APPLICATION NO.	FILING DATE	FIRST NAMED INVENTOR	ATTORNEY DOCKET NO.	CONFIRMATION NO.
10/595,342	04/11/2006	Terje H. Houen	1935-00233	7881
26753 7590 01/07/2010 ANDRUS, SCEALES, STARKE & SAWALL, LLP 100 EAST WISCONSIN AVENUE, SUITE 1100 MIL WALLEE, WI 52202			EXAMINER	
			CAMPOS, JR, JUAN J	
WIIL WAUNEE,	MILWAUKEE, WI 53202		ART UNIT	PAPER NUMBER
			3654	
			MAIL DATE	DELIVERY MODE
			01/07/2010	PAPER

Application No.	Applicant(s)			
Office Action Occurrence	10/595,342	HOUEN, TERJE H.			
Office Action Summary	Examiner	Art Unit			
	Juan J. Campos	3654			
The MAILING DATE of this communication app Period for Reply	ears on the cover sheet with the c	orrespondence address			
A SHORTENED STATUTORY PERIOD FOR REPLY IS SET TO EXPIRE 3 MONTH(S) OR THIRTY (30) DAYS, WHICHEVER IS LONGER, FROM THE MAILING DATE OF THIS COMMUNICATION. - Extensions of time may be available under the provisions of 37 CFR 1.136(a). In no event, however, may a reply be timely filed after SIX (6) MONTHS from the mailing date of this communication. - If NO period for reply is specified above, the maximum statutory period will apply and will expire SIX (6) MONTHS from the mailing date of this communication. - Failure

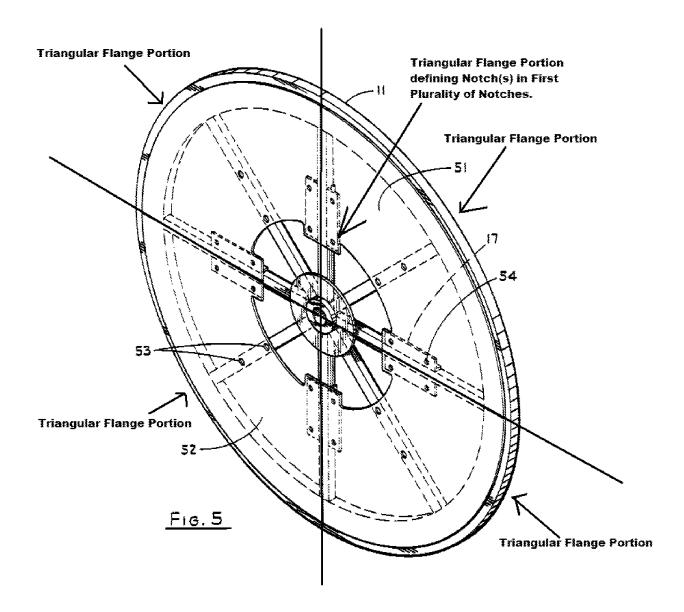
- **22. Regarding claim 35**, Harvey further shows wherein each flange sector 51 is capable of comprising a series of triangular flange portions (see column 5 lines 7-12. figure 5 and figure below), the triangular flange portions defining notches in the first plurality of notches (see figure 5 and figure below).
